SOLICITATION ADDENDUM

ADDENDUM NO. 1

Solicitation: **170481 – Asphalt Lot Repair & Resurfacing**

Project: Bill Bryson Subaru
 Subject: Striping Plan
 Date: 0.13.17 Sheet of
 Calculated/Notes by: Donna Davis

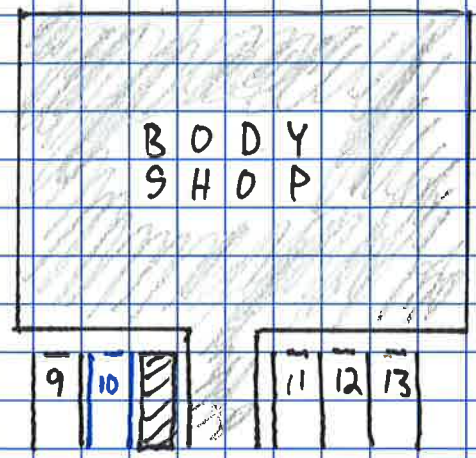
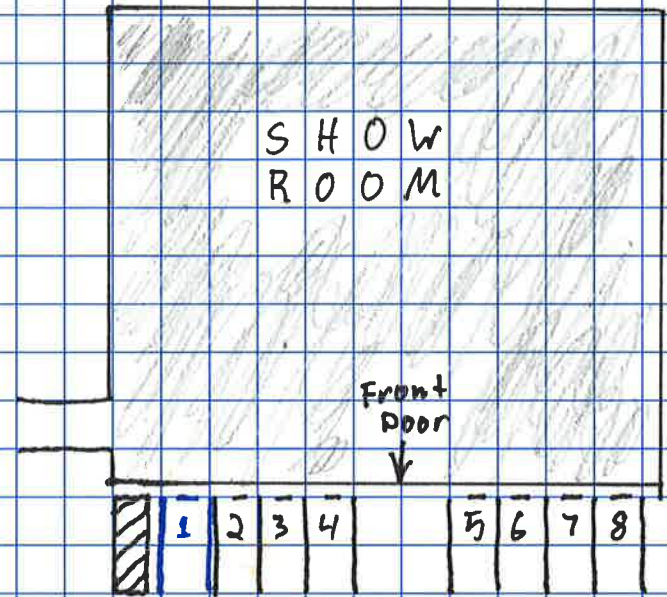
Lots 1 + 10 are to be handicapped.

- Handicap Specs
 - 12' with a 5' access that CANNOT be in conflict with existing ramp.
